M170019

Comment Summary Table and Draft SE Markup

Comment Summary for Draft Safety Evaluation for NEDE-33005P Revision 0, "TRACG Application for Emergency Core Cooling Systems / Loss-of-Coolant-Accident Analyses for BWR/2-6"

Figure 2. MELLLA+ Power-to-Flow Operating Domain.

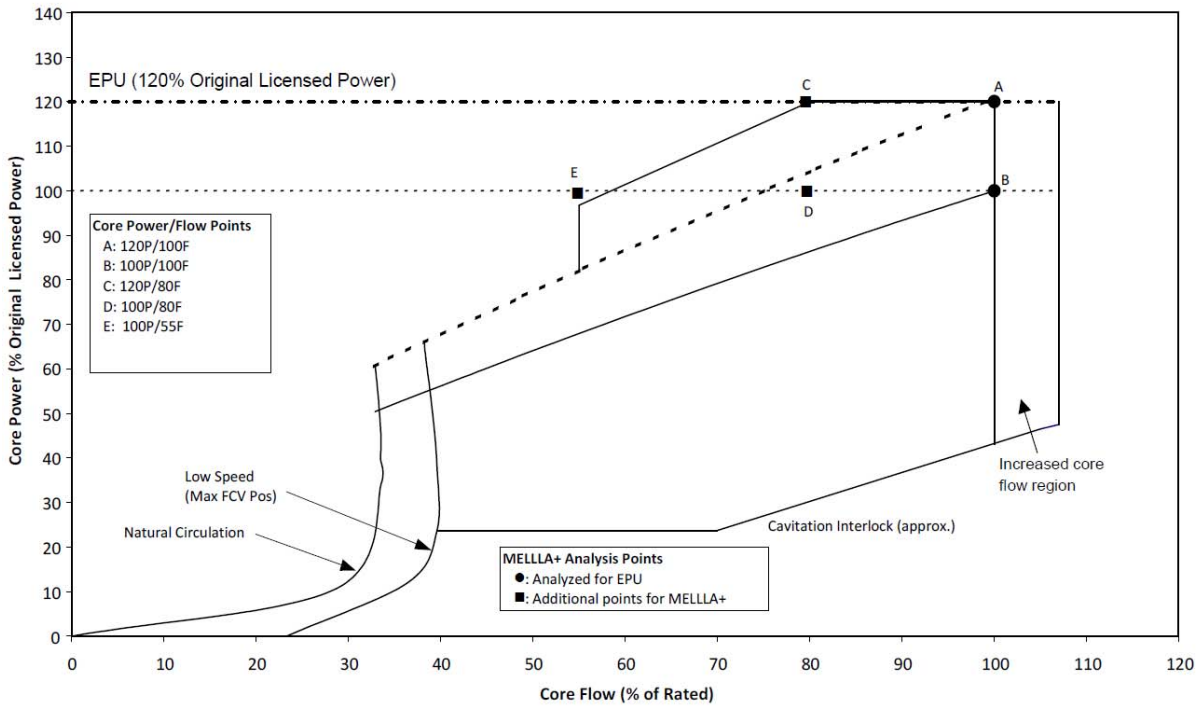
Section 5.2 Operating Statepoints	Page 21: The figure should be cited from the MELLLA+ LTR and referred to as typical since some plant-specific maps are different. GEH suggests the following change (Line 5): A typical ~~The~~ MELLLA+ operating domain is illustrated in Figure 1-1 of Reference 58 ~~Figure 2~~. *Suggested change shown in the markup.*
Section 5.2 Operating Statepoints	Page 21: The figure should be cited from the MELLLA+ LTR and referred to as typical since some plant-specific maps are different. If the figure is retained, then a better figure is needed since the figure in the SE has Points D and E misaligned. GEH suggests the following change (Line 7): Replace Figure 2 with Figure 1-1 from Reference 58.

Location	Comment
Section 5.2 Operating Statepoints	Page 21: If Figure 1-1 from Reference 58 replaces the existing Figure 2, then the points analyzed for MELLLA+ plants needs to be revised. GEH suggests the following change (Line 11): points ~~A~~ B, D, and E in Figure 2. *Suggested change shown in the markup.* Note that if the existing Figure 2 is not replaced, then the points should be A, C, and E.
Section 5.3 Power Distribution and Channel Groupings	Page 23: GEH suggests the following change (Line 29) the limiting heated nodes are *Suggested changes shown in the markup.*
Section 5.3 Power Distribution and Channel Groupings	Page 23: Standard and hot channel are the same. Clarify the footnote. GEH suggests the following change to Footnote H: Note that the standard channel nodalization~~, hot channel~~ includes [[ ]] axial nodes, of which 25 are heated. *Suggested changes shown in the markup.*

A typical~~The~~ MELLLA+ operating domain is illustrated in Figure 1-1 of Reference 58~~Figure 2~~.
